Committee of Adjustment

COMMITTEE OF ADJUSTMENT AGENDA

Location: Hearing:	COUNCIL CHAMBERS DECEMBER 12, 2019 AT 1:30 P.M.		
NEW APPLI	CATIONS (CONSENT)		
File B-076/19	Name of Applicant IQBAL NOOR & SHAHER BANO NOOR	Location of Land 5182 AMANA PL	
B-076/19	IQBAL NOOR & SHAHER BANO NOOR	5162 AMANA PL	
B-077/19 B-078/19	6608 DIXIE ROAD (MISSISSAUGA) INC	1420 MID-WAY BLVD	
	APPLICATIONS (CONSENT)		
File	Name of Applicant	Location of Land	
B-040/19 TO	MIDLEKS INC	3585 DIXIE RD	
B-042/19 A-290/19 TO			
A-293/19			
B-061/19 A-392/19	CAMCENTRE HOLDINGS INC	151 CITY CENTRE DR	
B-062/19	BABTIST CHURCH	1640 CARMEN DR	
D 002/10			
	CATIONS (MINOR VARIANCE)		
File	Name of Applicant	Location of Land	
A-457/19	MEMUSHI PERNASKA & MEMUSHI BESJANA	299 LOUIS DR	
A-466/19	ARMINDO JOAQUIM	1228 CANTERBURY RD	
A-467/19	ASSER EL SHANAWANY & VENIS NASR	1405 CRESTDALE RD	
A-468/19	LUSHES DEVELOPMENT INC	1996 LUSHES AVE	
A-469/19	MOHAMMED SOHEB PARMAR	7602 REDSTONE RD	
A-470/19	GIUSEPPINA CAPUTO & JULIAN MORA	560 VANESSA CRES

TO:	S. Kenney, Secretary Treasurer Committee of Adjustment	
FROM:	D. Martin Transportation and Works	
DATE:	November 29, 2019	
RE:	Applicant: Date of Hearing: Location: Our File:	Iqbal Noor & Shaher Bano Noor December 12, 2019 5182 Amana Pl 'B' 76/19, Ward 11 (Z-38W)

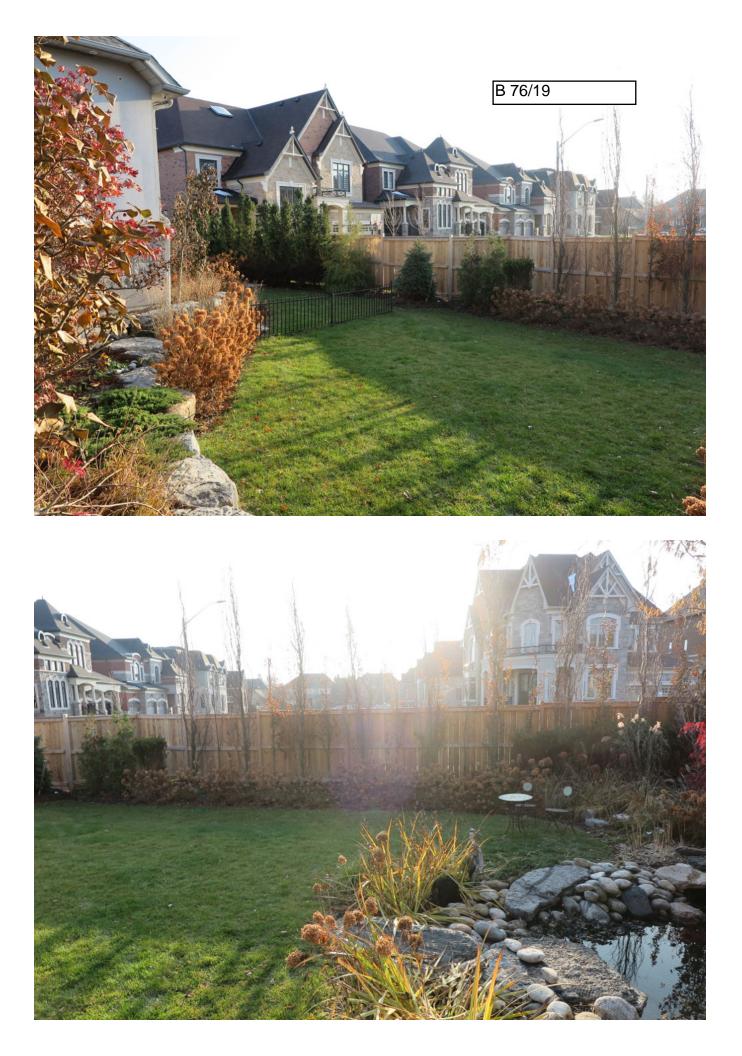
This Department has no objections or conditions for the applicant's request to attach the severed lands to the abutting property immediately to the south known as 5176 Amana Place. We note that the unique configuration of the severed lands was a result of a previous Consent Application where the Transportation and Works Department had to make provisions for a possible road connection to Amana Place for the abutting lands to the west which have recently been developed under Plan of Subdivision 43M-2046.

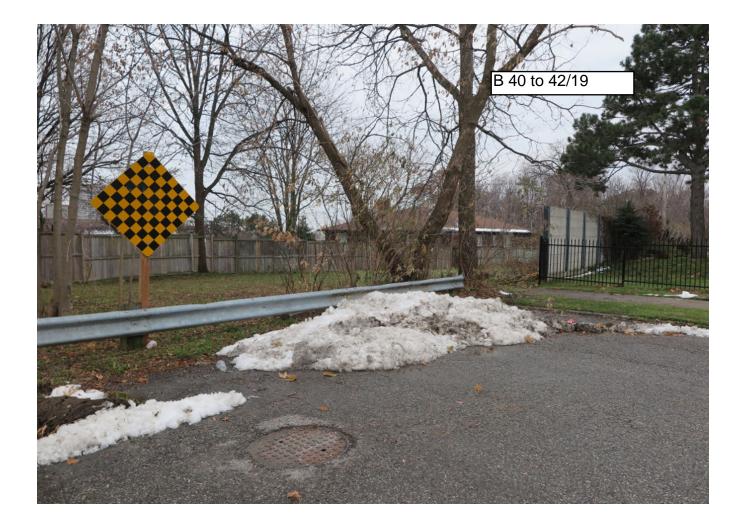
In view of the above, we strongly request that this application be **deferred** in order that the applicant can meet with City staff and Region of Peel staff to review how servicing and access through Gulleden Drive will be addressed with the proposed new lot configuration.

Re: C.A. 'A' 457/19 Memushi Pernaska & Memushi Besjana 299 Louis Dr Ward 7

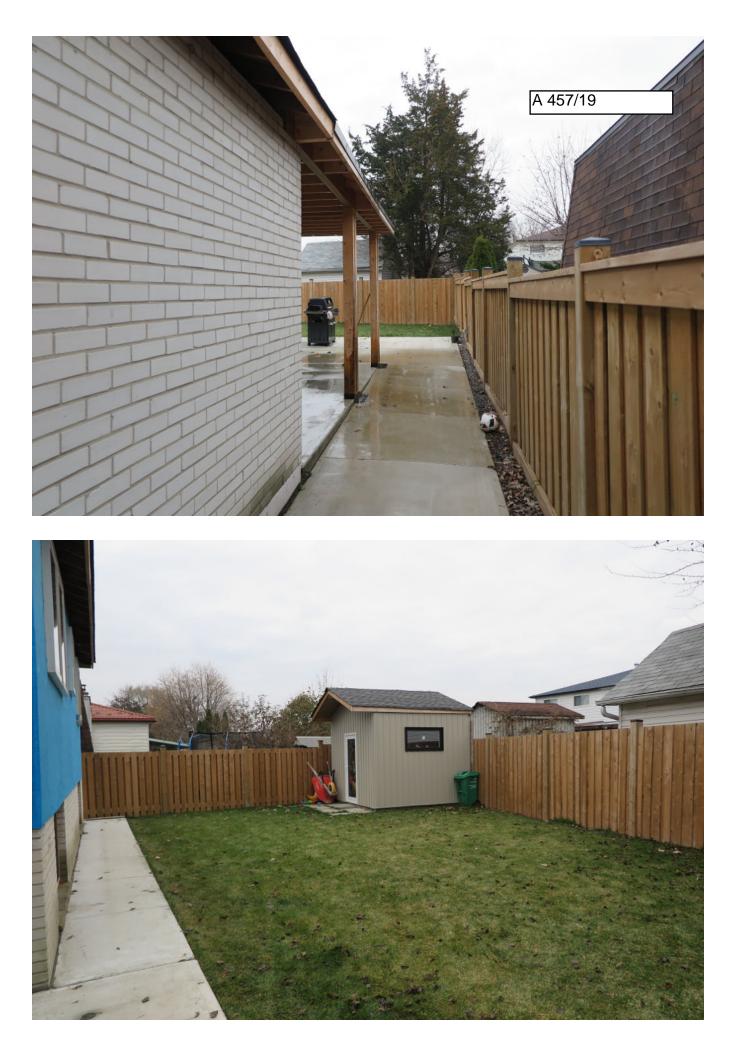
The Existing Site Plan (DWG No A01) submitted with the application does not accurately depict the driveway as it exists as a concrete walkway is depicted; however, this concrete walkway is actually part of the driveway which may require an amendment to Variance #2. We are enclosing for Committee's reference some photos which depict the existing driveway as widened. This department notes that with regard to the widened driveway within the municipal boulevard (the area between the municipal sidewalk and property line) we would request that this area be reinstated with topsoil and sod should the application be modified to reflect a smaller driveway width within the subject property or if the application is not supported by the Committee.

With regards to the variances for the shed and additions we would request that the roof structures be equipped with an eaves trough and the downspout(s) be located such that roof drainage is directed internal to the lot so as not to impact on the abutting properties. We acknowledge from our site inspection that the construction of these structures is not totally complete and assume that the owner will be installing the eaves trough and downspout(s) upon the approval of the requested variances.

Re: C.A. 'A' 466-19 Armindo Joaquim 1228 Canterbury Rd Ward 1

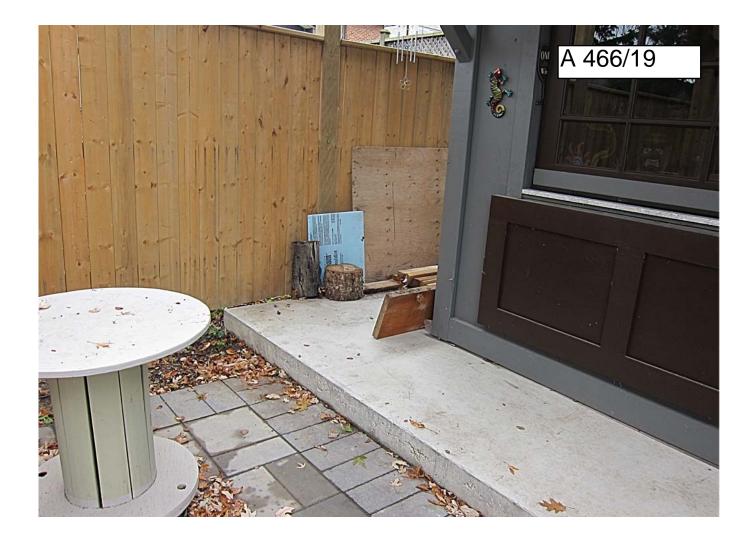
Enclosed for Committee's easy reference are photos depicting the existing shed. We have no concerns with the requested variance provided that the shed be equipped with an eaves trough across the rear portion of the roof and a down spout directed so as not to impact any adjacent properties.

Re: C.A. 'A' 467-19 Asser El Shanawany & Venis Nasr 1405 Crestdale Rd Ward 2

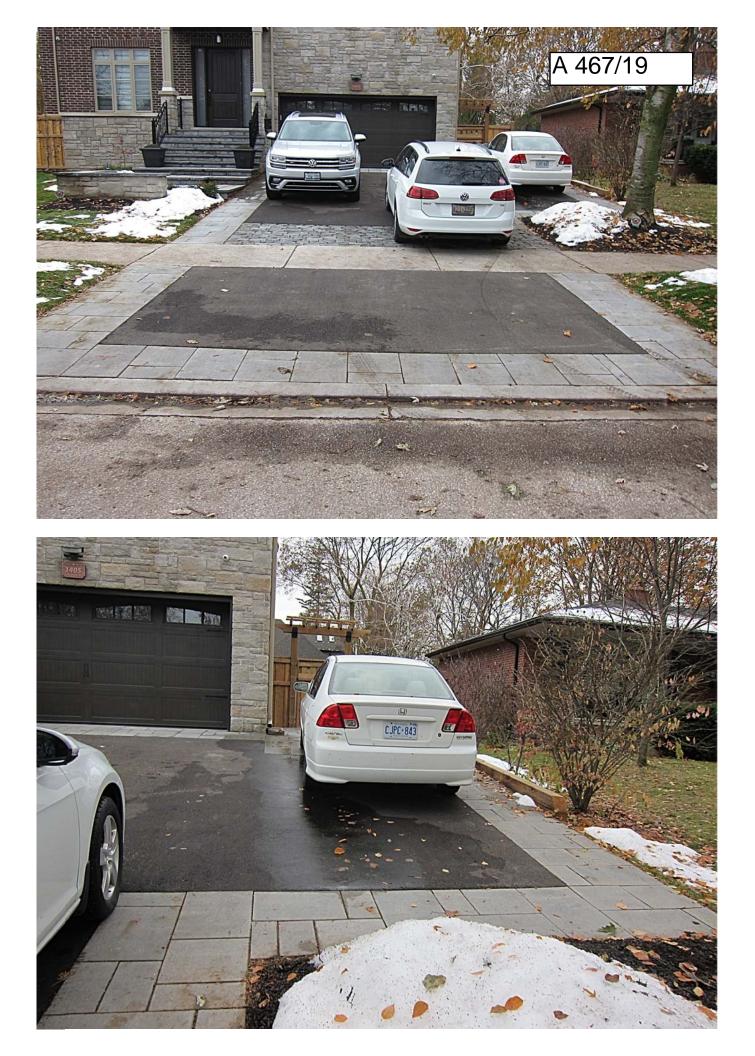
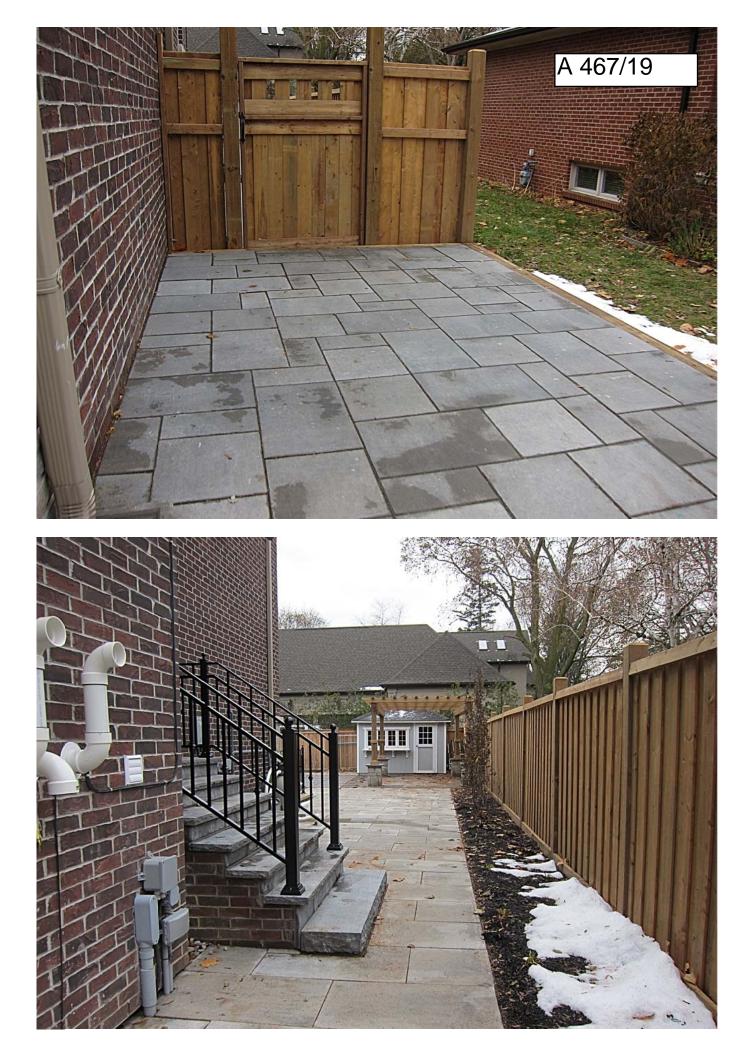
Enclosed for Committee's easy reference are photos depicting the existing driveway configuration and also the existing shed on site. We have no concerns with the requested variances provided that the shed be equipped with an eaves trough and a down spout directed so as not to impact any adjacent properties.

Re: C.A. 'A' 476/19 ASPE 1861 Holdings Inc 3017 Olympus Mews Ward 9

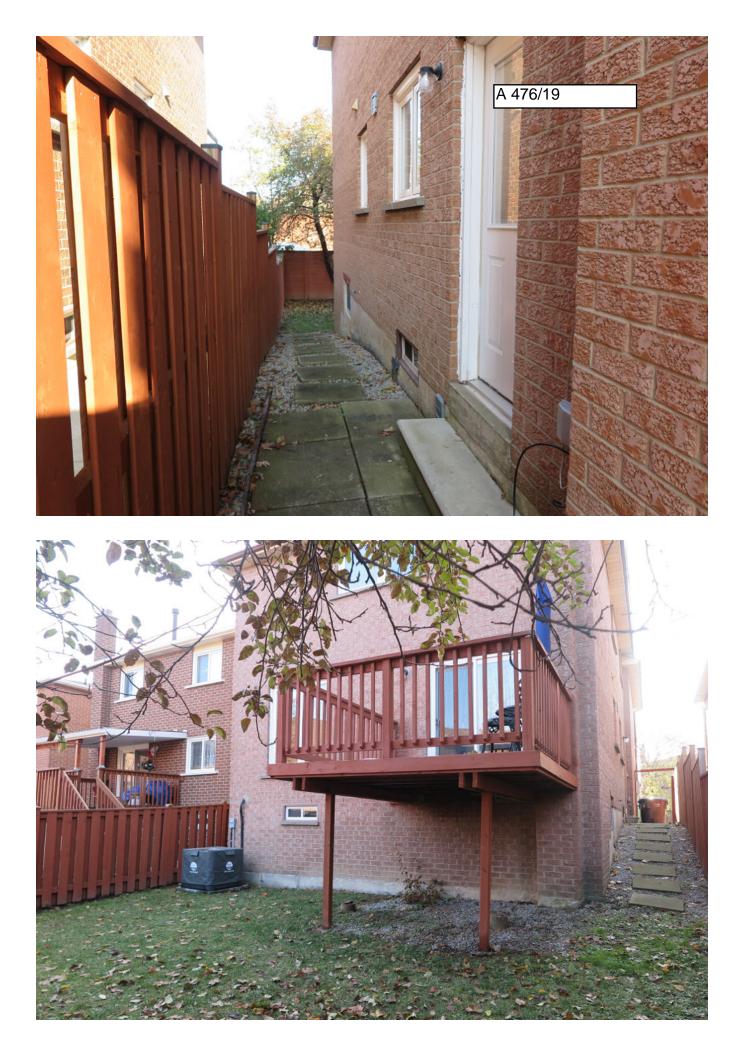
Information submitted with this application is somewhat confusing as a variance to allow a deck with a south-easterly side yard setback of 0.00M is being requested. Information and plans submitted with the application does not appear to reflect the proposed setback. Acknowledging that the proposed deck would typically not have much impact on grading or drainage of the lot, this department would have no objections to the request provided that the existing drainage pattern of the subject property be maintained.
